NOAA FORM 76-35A	
U.S. DEPARTMENT OF COMMERCE NATIONAL OCEANIC AND ATMOSPHERIC ADMINISTRATION NATIONAL OCEAN SURVEY	
DESCRIPTIVE REPORT (HYDROGRAPHIC)	
Type of Survey .....	HYDROGRAPHIC
Field No. ....	LA-05-1-76
Office No. ....	H-9657
LOCALITY	
State .....	OHIO
General Locality .....	SOUTH SHORE LAKE ERIE
Locality .....	DUMPING GROUND, NW of CONNEAUT
19 76	
CHIEF OF PARTY William R. Daniels	
LIBRARY & ARCHIVES	
DATE .....	December 29, 1977

FORM C&GS-537 (8-66)	U.S. DEPARTMENT OF COMMERCE ENVIRONMENTAL SCIENCE SERVICES ADMINISTRATION COAST AND GEODETIC SURVEY	REGISTER NO.  H-9657
<b>HYDROGRAPHIC TITLE SHEET</b>		FIELD NO. LA 5/1/76

ATLANTIC MARINE CENTER  
VERIFIER'S REPORT

SUBJECT: Quality Control Report for H-9657 (1976), Ohio South Shore,  
Lake Erie, Dumping Ground Northwest of Conneaut

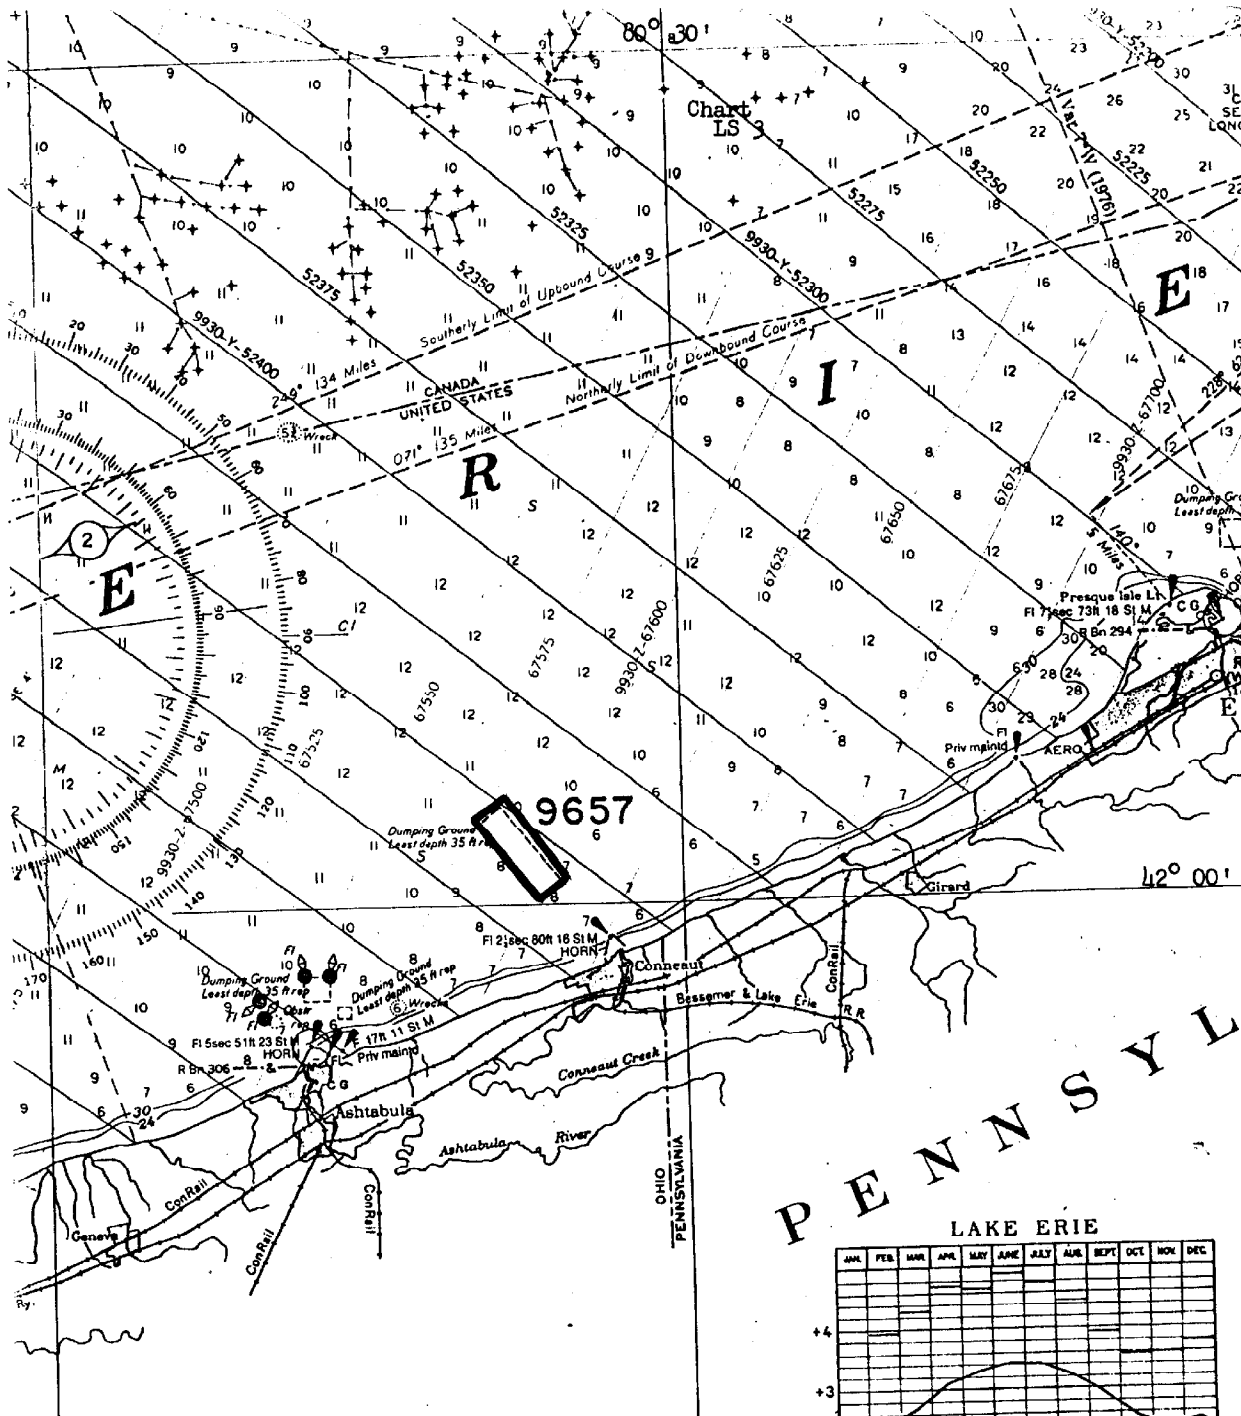
1. Reference section 6 of the Verifier's Report:

Hydrographic survey 1-2037 also covers a portion of the area of the present survey but was not noted in the Verifier's Report. It was therefore compared with the present survey and added to the Verifier's Report during quality control evaluation. The discussion of the comparison in section 6 of the Verifier's Report also applies to survey 1-2037 and is supplemented by the following:

The comparison reveals good general agreement of depths within the common area with scattered depth differences of  $\pm 3$  feet.
